Cabot Corp. - Second Disposal Well
Log #1423-74

The following information is submitted in answer to the six specific points raised in your letter of November 7, 1974.

PROPOSED COMPLETION AND GEOLOGIC
COLUMN OF NO 2 DISPOSAL WELL

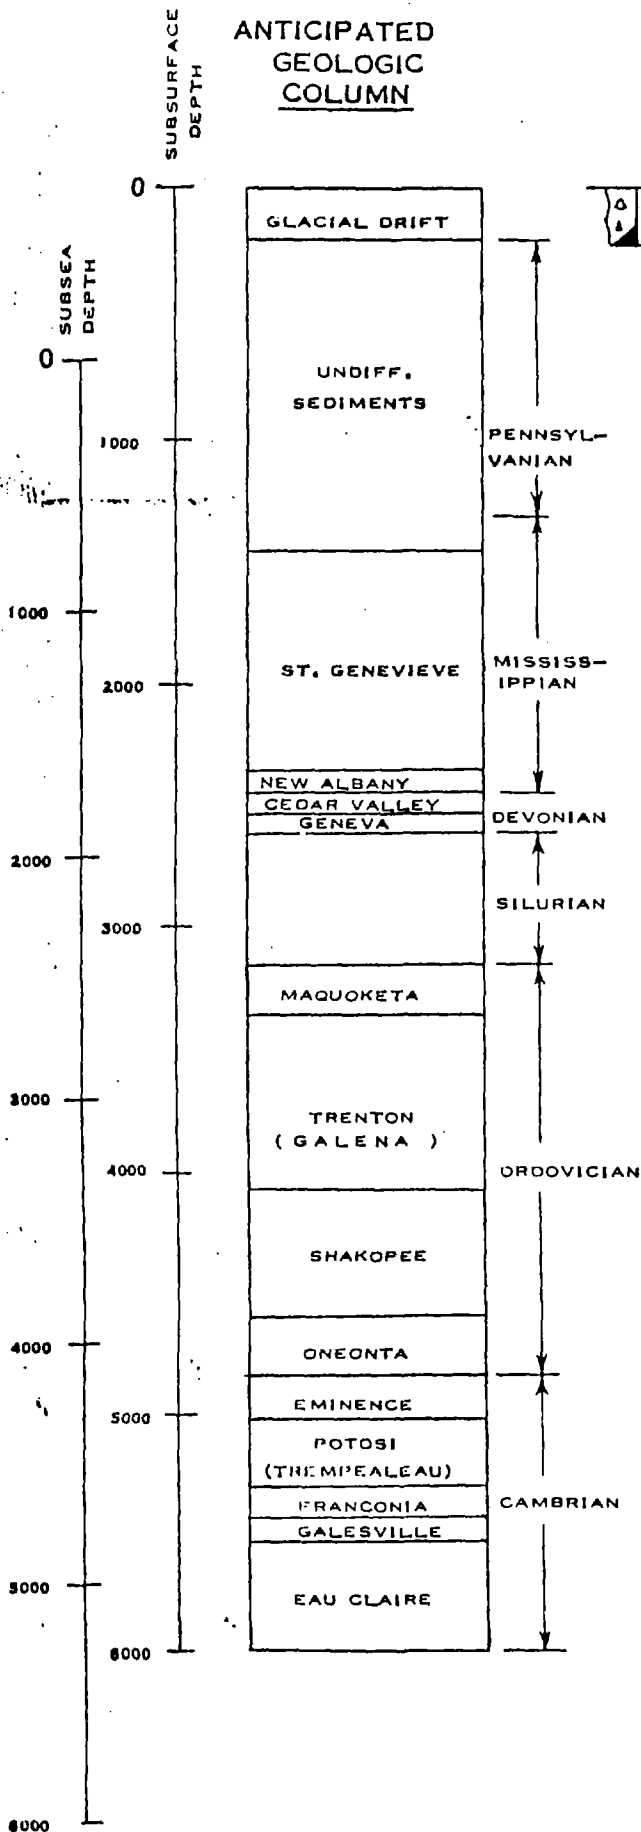
EPA Question 3) Formation tops and names should be updated on the well schematic and in the text of proposal. The elevation of tops taken from geophysical logs should be corrected for differences in surface elevations and the distance between the measuring position and ground level.

EPA Question 4) The types of cement for grouting have not been identified. The acidic character of the waste may require special cement at the base of the 7" casing.

Answer 3) A more complete elevation drawing of the proposed well completion is attached. Depths of the local formations are listed beside the geologic column. For convenience, these depths are shown subsea as well as subsurface.

Answer 4) The types of cement to be used behind each of the casing strings are shown on the enclosed elevation drawing. It should also be noted that the proposed well will have almost 200 feet of oil seal below the casing seat as a secondary defense against acid erosion in this portion of the hole.
